From: S22
Sent: Friday, March 9, 2012 6:12 AM
To: Fagervik, Kirsten TRAN:EX
Cc: S22
Subject: DL2704 Gambier Island

From: S22
Sent: Friday, November 18, 2011 11:29 AM
To: Moore, Jeffrey TRAN:EX; Fagervik, Kirsten TRAN:EX
Subject: RE: DL2704 Gambier Island Subdivision

PLAN SHOWING PROPOSED PROPORTION OF
DISTRICT LOT 2704
EXCEPT PART INCLUDED IN PLAN 15941
GROUP ONE, NEW WESTMINSTER DISTRICT
P.L.D. 015-951-828

OPTION K:

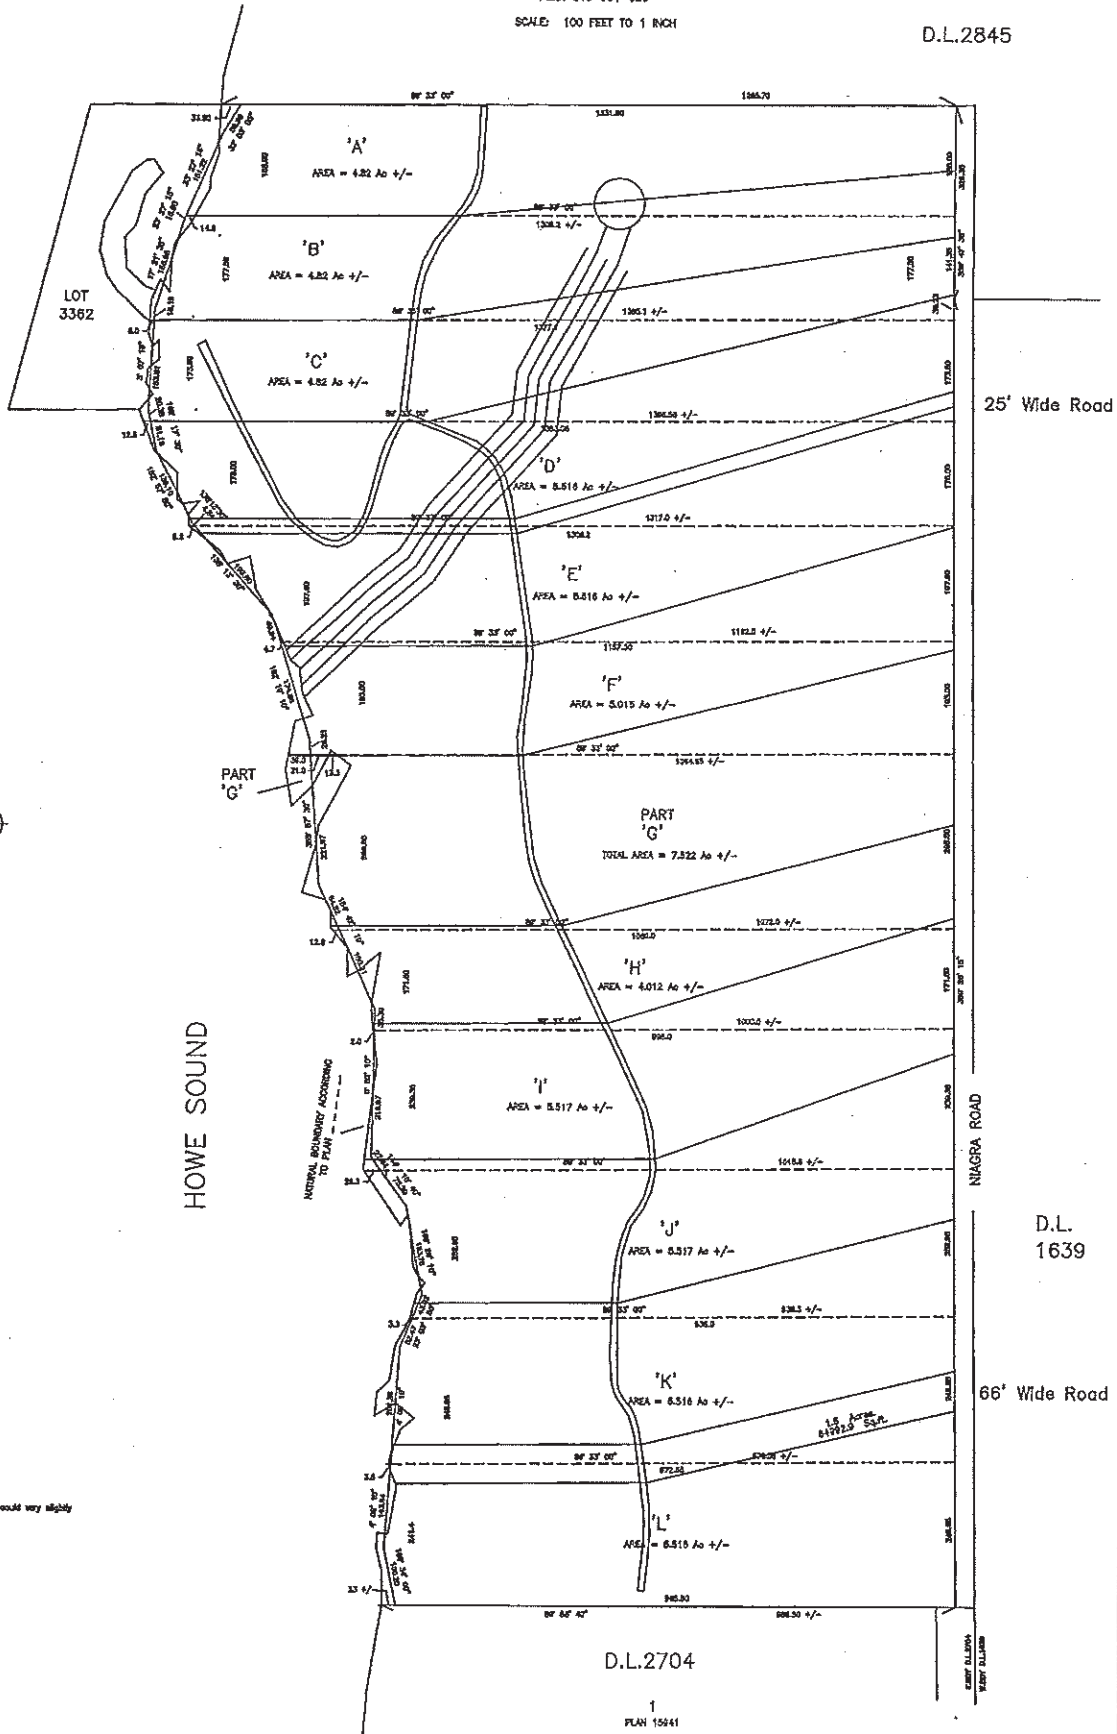
Could you take a look at the options presented and forward any comments you have to S22. I prefer option K as it comes closest to meeting the requirements of the act but we will need confirmation that the access routes are viable.
